2 May 2019

SECTION 4.55 (1A) MODIFICATION APPLICATION – STATE SIGNIFICANT DEVELOPMENT APPLICATION 6952 WENONA SCHOOL

Figure 2 Proposed location of substation

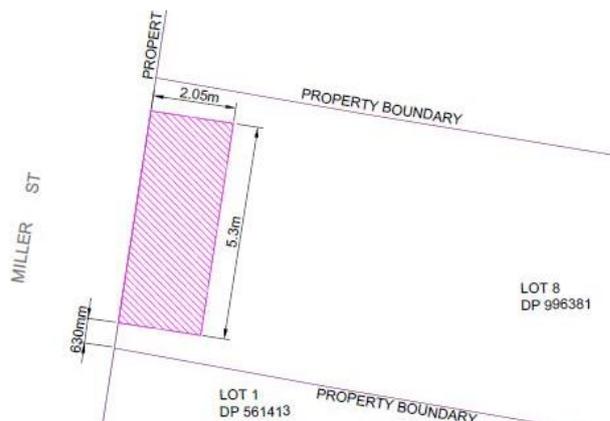
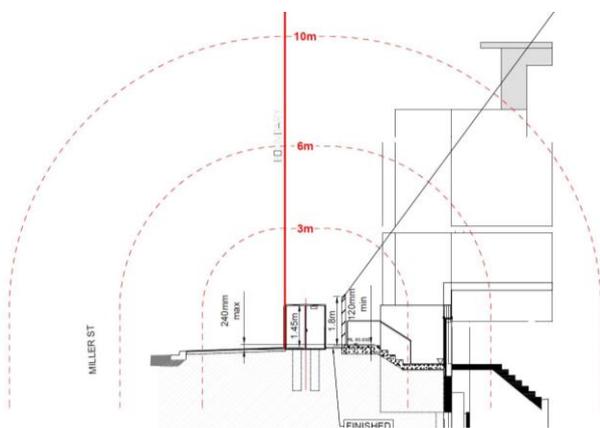
The proposed modifications are illustrated in the Architectural Drawings at **Attachment A**. The modification relates to the repositioning of the substation 2.25m to the south, as shown in **Figures 1 - 2**. The proposed positioning of the substation represents a minor relocation.

Consistent with the approval, the substation maintains a separation distance from the adjacent classroom window in excess of 3m to ensure that there is sufficient blast protection. It is also noted that the proposed location does not encroach on the below ground reinforced concrete structure positioned to the north along the Miller Street frontage.

Figure 3 Proposed section view of substation

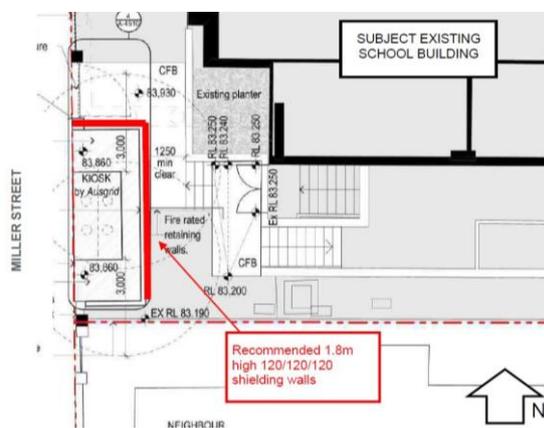
The modification also seeks consent for the inclusion of a 120/120/120 fire resistant wall with a height of 1.8m (refer to **Figure 3** and **Attachment D**). The wall will be located along the northern and eastern perimeters of the substation where it interfaces with the adjacent classrooms and pedestrian pathway that provides access to the gymnasium. The fire-resistant wall will consist of reinforced blockwork and is included for the purpose of maximising protection in the unlikely instance there is a fire within the substation. The fire resistant wall will sit external to the fence that is approved to surround the substation.

Figure 5 Substation and approved fence as viewed from the Miller Street frontage

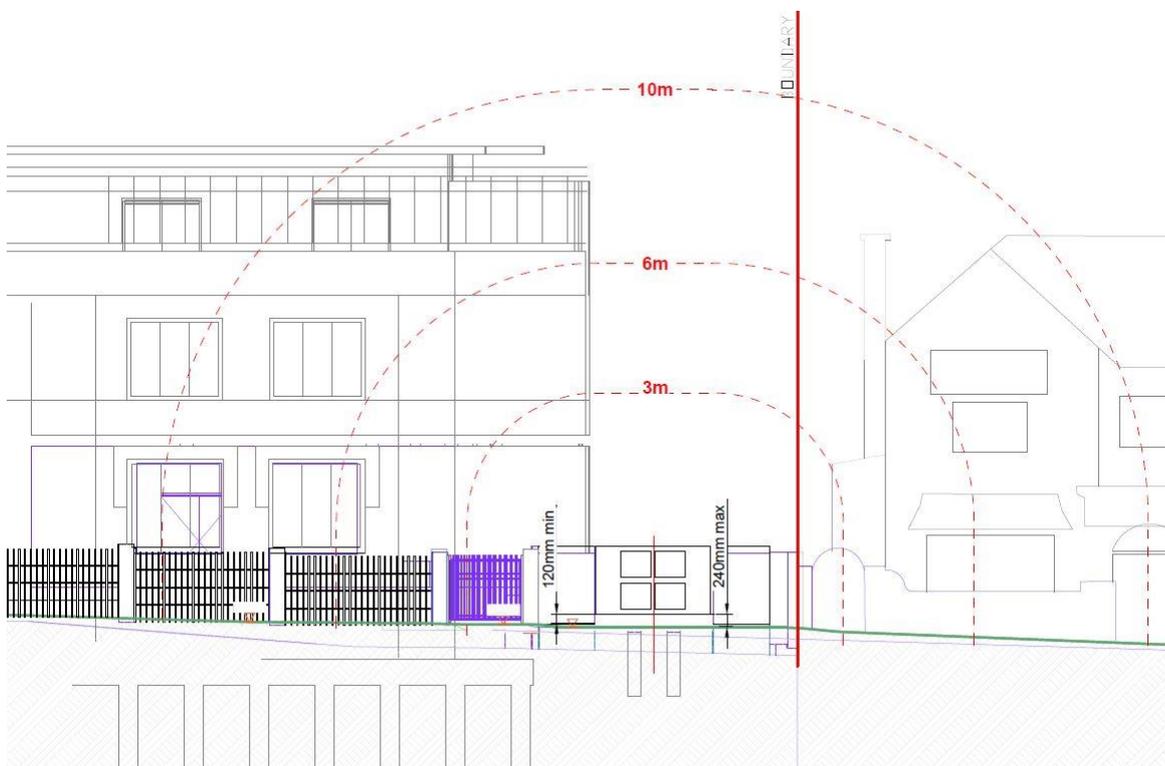
As addressed previously, the proposal seeks consent for the inclusion of a fire resistant barrier in order to satisfy Ausgrid’s requirements. Notwithstanding the concerns noted by the Department in relation to streetscape impacts, the fire resistant barrier will be located along the eastern and northern perimeters of the kiosk substation. Consequently, it will not be visible from the Miller Street frontage. As per the approved development, the substation will continue to be partially concealed by a metal fence that corresponds with the materiality of the existing fence along Miller Street (refer to **Figure 5**). Accordingly, the appearance of the substation when viewed from the street frontage will remain generally unchanged from the approved development.
